Refat Garments Ltd (Extended Building)

1st June & 5th September 2021

Observations

Loading parameter for lateral load

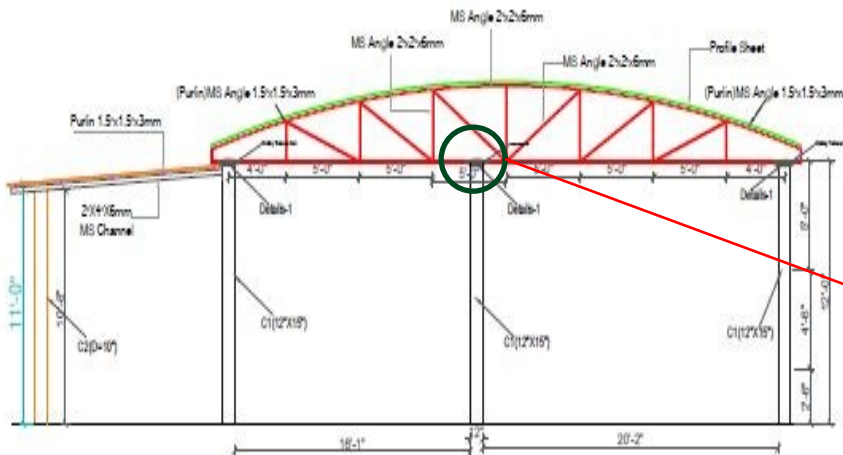
A Design Report is prepared including design parameters for wind and seismic loads. However, no detail calculation has been provided for wind and seismic loads. Also, all the load combinations from BNBC part-6 are not considered in Design Report. Factory engineer is required to include detailed wind and seismic load calculations/analysis output, all load combinations, stability check for all structural members and update the Design Report in compliance with the BNBC (section 1.9.1 of part-6).

7 Observations: New Child Care Building

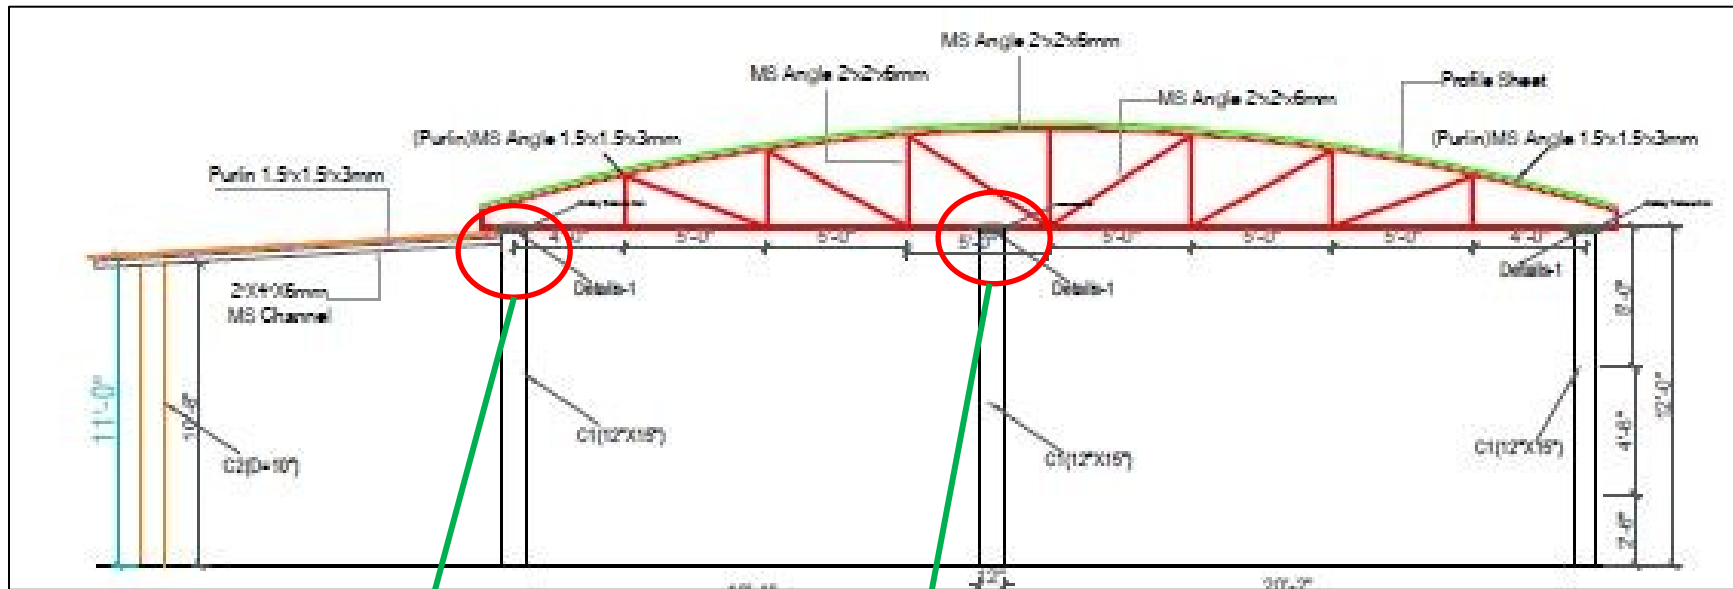
Lack of lateral stability

Poor connection details

Load path not clear

The steel roof shed made of steel truss section which is supported by RC column and brick wall in both direction. No horizontal bracing members are available for lateral stability. Apparently Inadequate structural member, poor connection details found and unclear load path. Building engineer is required to check the adequacy of the steel members & connection for uplift and lateral forces otherwise replace with engineered structure.

Sectional Detail of Truss

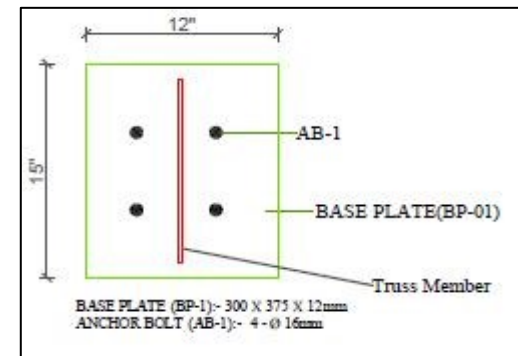
Discrepancies in as-built drawings

There were double angle in bottom chord which was not mentioned in as-built drawing. Also, Connection detail between column and truss was shown bolted with base plate which was found welded. C-channel was connected with brick wall not with RC column (as per provided drawing). Factory engineer to survey the structure and update as-built drawings for the structure.

Beam layout

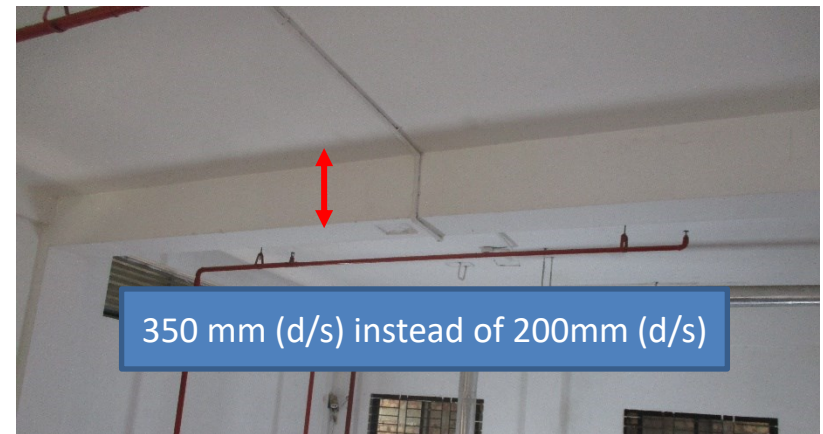
Discrepancies in as-built drawings

Undocumented steel stair

Beam size found 250 X 350 mm (d/s) instead of 250 X 200 mm (d/s) in transverse direction. Undocumented steel stair not mentioned in as-built drawing. Factory engineer to survey the structure and update as-built drawings for the structure.

Roof truss layout

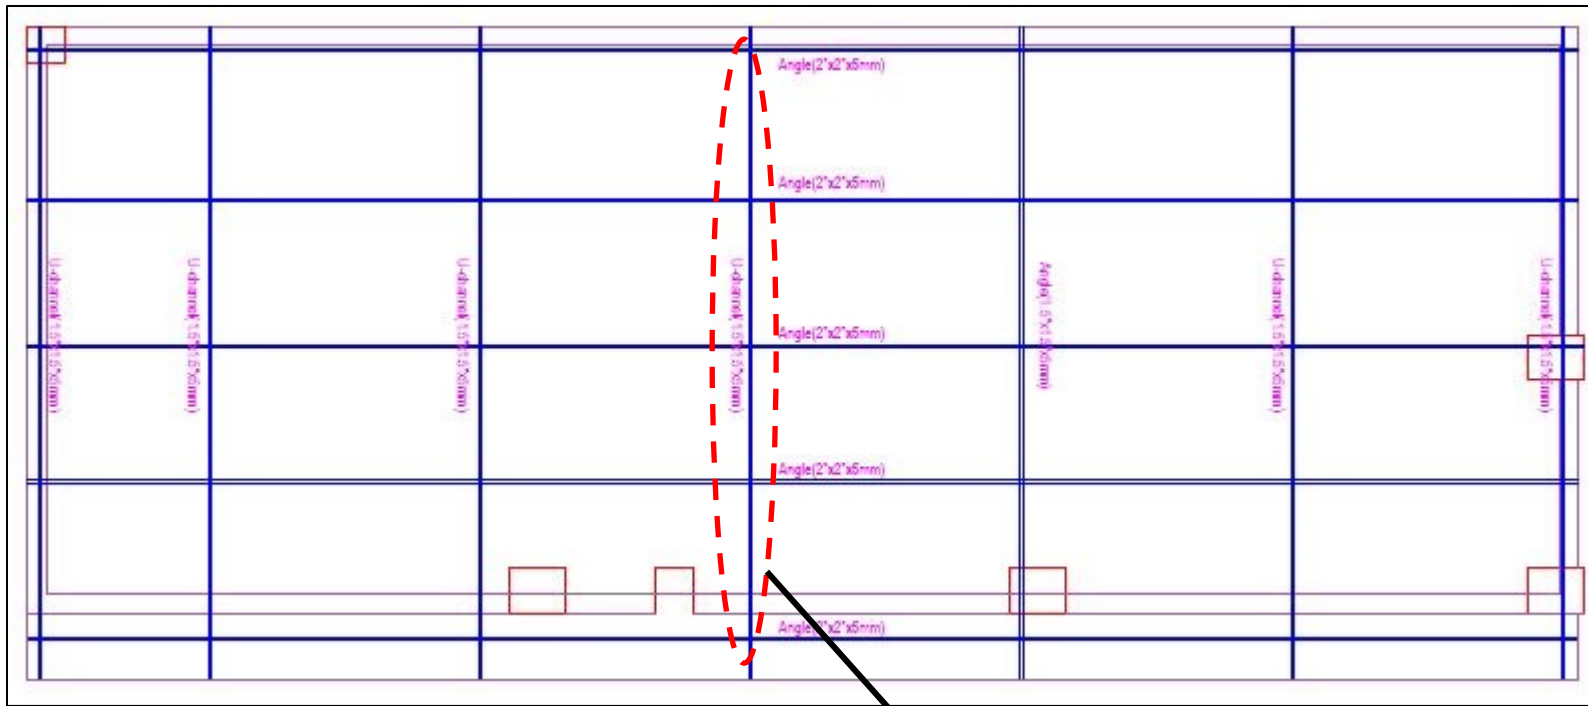
Discrepancies in as-built drawings

C channel size was found 38x75x5 mm instead of 38x38x5 mm. Factory engineer to survey the structure and update as-built drawings for the structure.

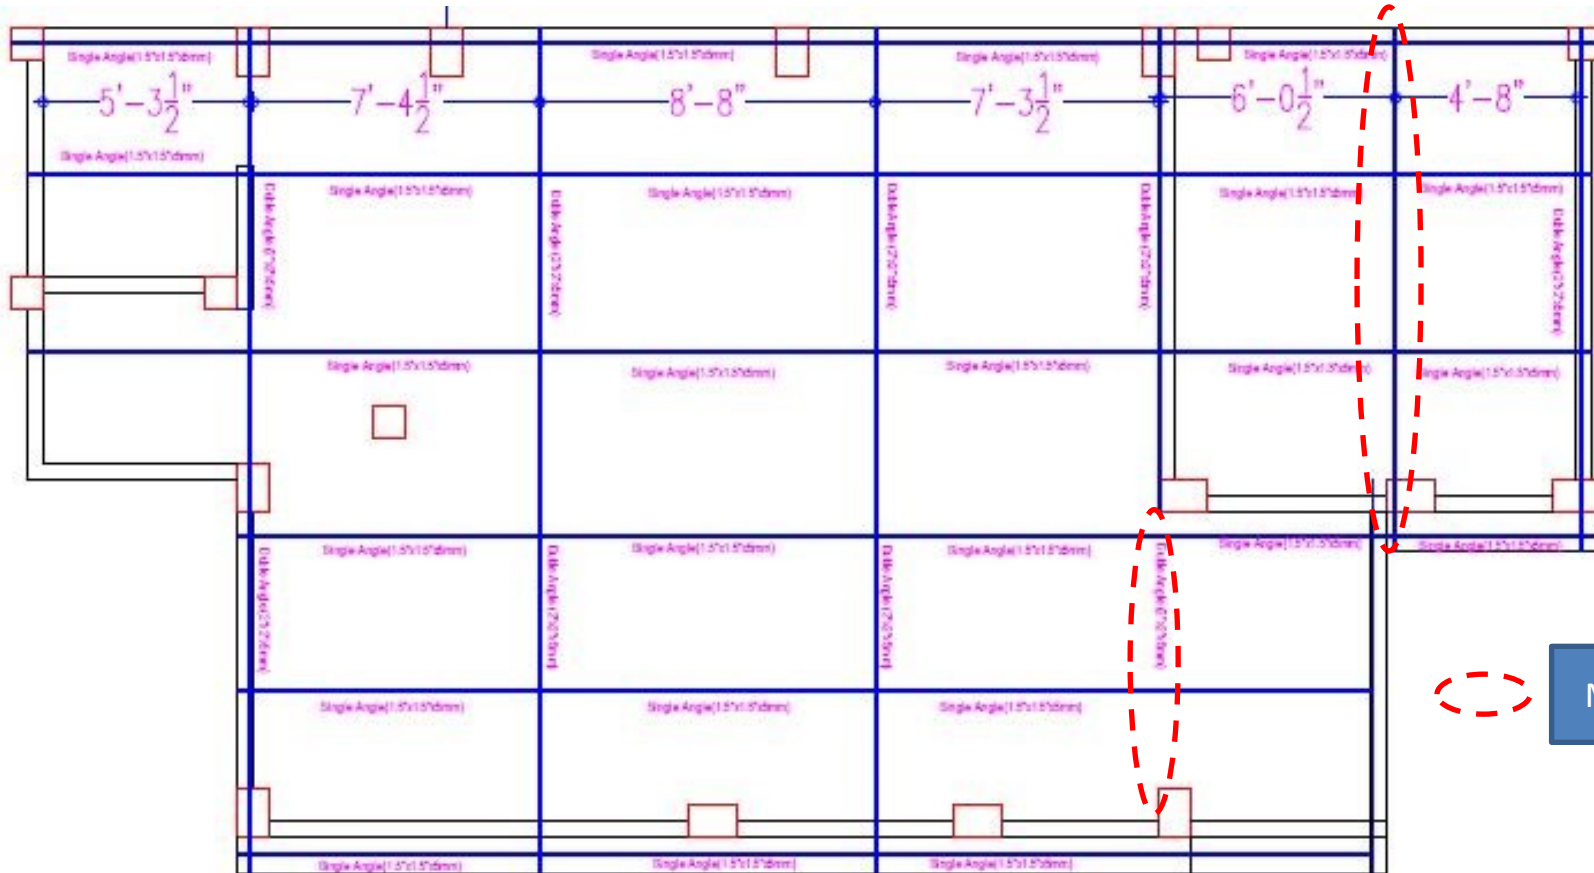
Apparently Non-engineered shed

Apparently inadequate structural members

Apparently Inadequate structural member, poor connection details found. Building engineer is required to check the adequacy of the steel members & connection for uplift and lateral forces otherwise replace with engineered structure.
